SCHWEIZER SERVICE BULLETIN

B-256.2*
11 June 1993

SUBJECT: INSPECTION OF CLUTCH CONTROL SPRING ASSEMBLY INSTALLATION

Figure B-256.2-1. Belt Drive Clutch Control Installation (Sheet 1 of 2)

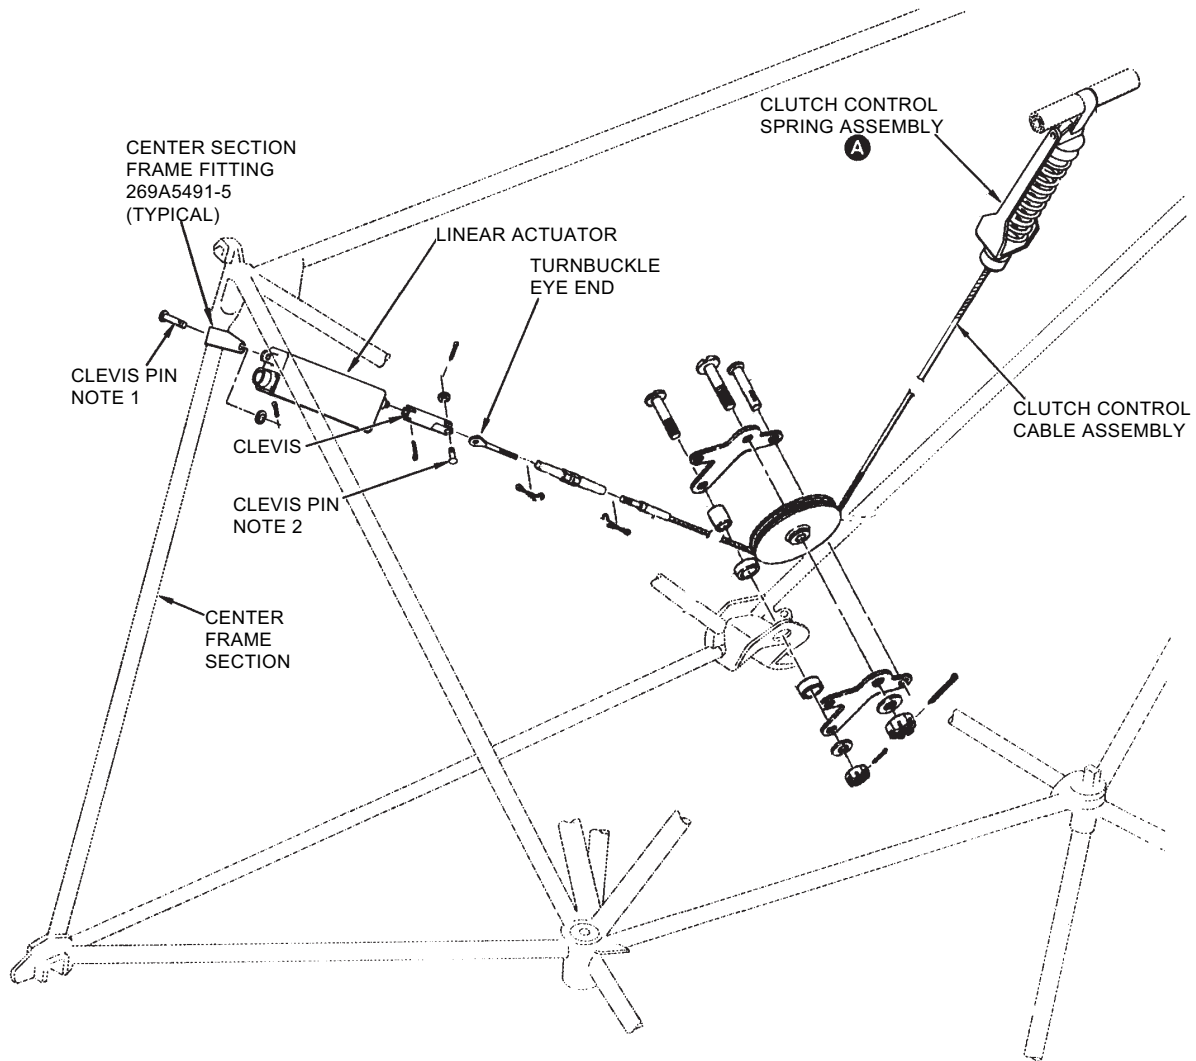
- a. Using applicable steps of Basic HMI Section 10 as a guide, disassemble the clutch control installation as necessary to remove affected clevis pins (Figure B-256.2-1).

- b. Using specified hardware (Figure B-256.2-1), replace each of the removed clevis pins in accordance with the following requirements:
 - (1) Install bolt with a minimum of one washer at nut end. Verify that spring fitting does not contact bolt threads; refer to Figure B-256.2-2 for typical example.

1. IF 269A5491-5 WELDED FITTING IS INSTALLED (SHOWN): REPLACE CLEVIS PIN WITH NAS1304-8D BOLT, AN960-416L WASHER, MS17826-4 NUT, AND MS24665-151 COTTER PIN. (IF 269a5490 BOLTED FITTING IS INSTALLED, A NAS1304-12D BOLT WILL BE REQUIRED.)
2. REPLACE CLEVIS PIN WITH NAS1303-7D BOLT, AN960-10L WASHER, MS17826-3 NUT, AND MS24665-151 COTTER PIN.
